UNITED STATES PATENT AND TRADEMARK OFFICE

APPLICATION NO.	FILING DATE	FIRST NAMED INVENTOR	ATTORNEY DOCKET NO.	CONFIRMATION NO.
10/711,842	10/08/2004	Markus Reiter	20067US	5841
23470	7590	01/28/2008	EXAMINER	
SRAM CORPORATION 1333 N. KINGSBURY, 4TH FLOOR CHICAGO, IL 60622				IRVIN, THOMAS W
ART UNIT		PAPER NUMBER		
3683				
			NOTIFICATION DATE	
			DELIVERY MODE	
			01/28/2008	
			ELECTRONIC

Office Action Summary	Application No.	Applicant(s)
	10/711,842	REITER, MARKUS
	Examiner	Art Unit
	THOMAS W. IRVIN	3683

DETAILED ACTION

FIG. 12

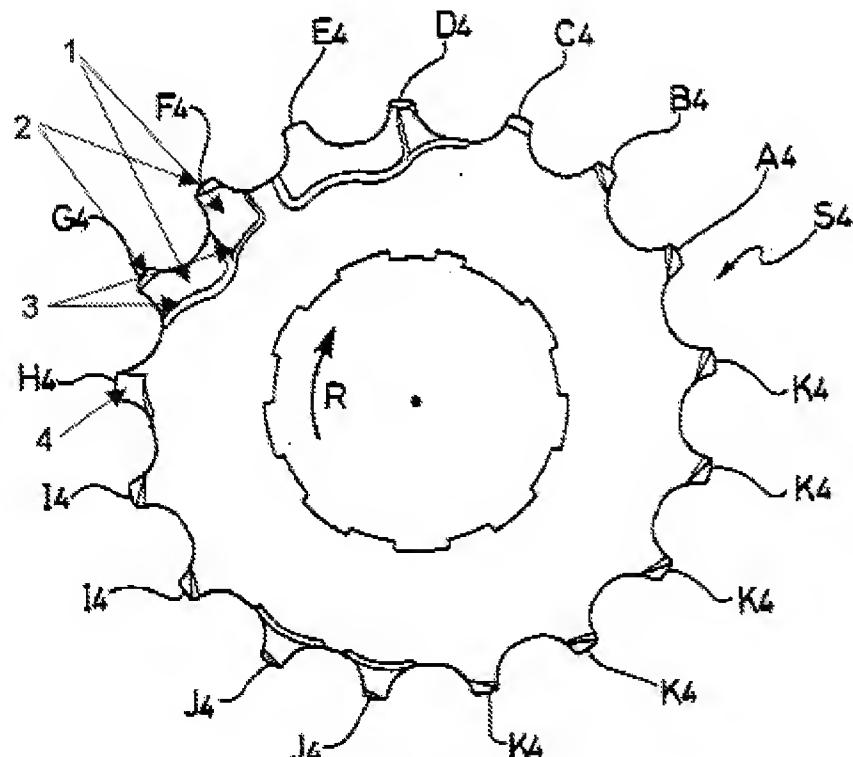
In Re claim 1, with reference to Fig. 3, 13, and 12 (above), '338 discloses a chainwheel assembly including a plurality of chainwheels (s1-s7) engageable with a

chain (23) having successive alternating pairs of inner link plates and outer link plates connected by pins, the pins surrounded by rollers, the chainwheel assembly comprising: at least one smaller chainwheel (s3) having a plurality of teeth spaced about its circumference; and at least one larger chainwheel (s4) having a greater number of teeth spaced about its circumference than the smaller chainwheel, the larger chainwheel and the smaller chainwheel oriented relative to each other such that a distance between a center of the chain roller positioned between a pair of adjacent teeth on the larger chainwheel and the center of the chain roller between a pair adjacent teeth on the smaller chainwheel is substantially an integer multiple of the chain pitch, at least a first tooth (f4) of the pair of adjacent teeth (F4,G4) on the larger chainwheel includes a lateral recess (1) disposed on a front face of the larger chainwheel facing the smaller chainwheel to allow the chain to move from the smaller chainwheel towards the larger chainwheel, at least a second tooth (G4) of the pair of adjacent teeth disposed adjacent to the first tooth opposite the drive rotation direction having a configuration to prevent the second tooth from capturing the chain.

In Re claim 2, '338 further discloses that the recess is configured to include a run-on ramp (3) for lifting the chain, the run-on ramp extending to a tooth root of the second tooth.

In Re claim 3, '338 further discloses that the run-on ramp extends, at the tooth root, into the outer periphery of the larger chainwheel.

In Re claim 4, '338 further discloses that the second tooth includes a recess for lifting the chain (1).

In Re claim 5, '338 further discloses that the larger sprocket includes a third tooth (H4) disposed adjacent the second tooth opposite the drive rotation direction includes a run-out chamfer (4) disposed on the front face of the larger chainwheel, the run-out chamfer extending obliquely backward opposite to the drive rotation direction to provide a shifting lane for the link plate.

In Re claim 6, '338 further discloses that the two recesses (1) are combined into one recess extending over the first tooth and the second tooth.

In Re claim 7, '338 further discloses that the recess has a depth approximately equal to a thickness of the link plate.

In Re claim 8, '338 further discloses that the second tooth (G4) includes a deflection chamfer (2) directed toward the smaller chainwheel to prevent the second tooth from capturing the chain.

In Re claim 9, '338 further discloses that the deflection chamfer is pronounced on an edge of the second tooth pointing in the drive rotation direction and tapers off toward a back of the tooth on an opposite edge of the second tooth.

In Re claim 12, '338 further discloses that the first tooth and the second tooth each include a deflection chamfer (2) directed toward the smaller chainwheel to prevent the first tooth and the second tooth from capturing the chain.

In Re claim 15, '338 further discloses that the tooth backs of the first tooth and the second tooth are located directly on a back face of the larger chainwheel facing the next larger chainwheel such that at an end of the shifting operation, the inner link plate

has traveled a maximum axial shifting distance before it slides over the tooth back before the chain capture tooth.

In Re claim 16, '338 further discloses that the first, second and third tooth comprise tips that are chamfered on the front face (2,4).
